Access Compliance Report Public Rights-of-Way (Curb Ramps)

Main Street: ETHEREAL_RD Cross Street: NARROW_CANYON_RD Location: N

ADA ID: RPRK211027135131 Ramp Type: Type 1 - Perpendicular Initial Pass/Fail: Fail Overall Compliance: No Severity Score: 16

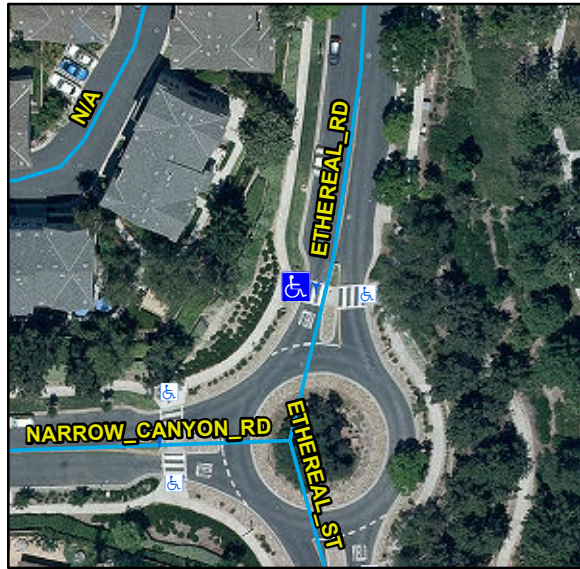
Compliance	Description	Data	Compliance	Description	Data
N/A	Ramp Length (in)	88	N/A	Flare Type LT	
Yes	Ramp Width (in)	48			N/A
No	Ramp Run Slope (%)	11.2	N/A	Flare Slope LT (%)	N/A
No	Ramp Cross Slope (%)	4	N/A	Flare Traversable LT	N/A
N/A	Landing Present	N/A	N/A	Flare Type RT	
N/A	Landing Length (in)	N/A			N/A
N/A	Landing Width (in)	N/A	N/A	Flare Slope RT (%)	N/A
N/A	Landing Run Slope (%)	N/A	N/A	Flare Traversable RT	N/A
N/A	Landing Cross Slope (%)	N/A	N/A	DWS Provided	N/A
N/A	Landing Movement Obstructed?	N/A	N/A	DWS Contrast	N/A
	Landing Movement Type	N/A	N/A	DWS Length (in)	N/A
N/A	Landing Shared	N/A	N/A	DWS Full Width	N/A
N/A	Clear Space	N/A	N/A	DWS Offset Left (in)	N/A
N/A	Clear Space To Crosswalk (in)	N/A	N/A	DWS Offset Right (in)	N/A
N/A	Marked Crosswalk 1	Yes	N/A	Marked Crosswalk 2	N/A
	Crossing 1 Direction	E		Crossing 2 Direction	N/A
	Marked Crosswalk 1 Width (in)	144		Marked Crosswalk 2 Width (in)	N/A

N/A	Ramp Inside Crosswalk 1	Yes	Yes	Ramp Inside Crosswalk 2	N/A
	Crossing 1 Slope (%)	2.5		Crossing 2 Slope (%)	N/A
	Crossing 1 Cross Slope (%)	1.8		Crossing 2 Cross Slope (%)	N/A
N/A	Gutter Ponding	N/A	No	Curb Slope	8.8
Yes	Gutter Lip Height (in)	0		Road Run Slope (%)	N/A
N/A	Gutter Run Slope (%)	N/A		Road Cross Slope (%)	N/A
N/A	Gutter Cross Slope (%)	N/A			
Yes	Overall Surface Condition: Acceptable		No	Perp Joint Present	No
	Cross Gutter Present?	No		Spandrel Present?	No
	Replace Cross Gutter?	N/A		Replace Spandrel?	N/A

Remove & Replace Entire Ramp.

R304.2.2, R204.3, R304.5.3, STD 1115
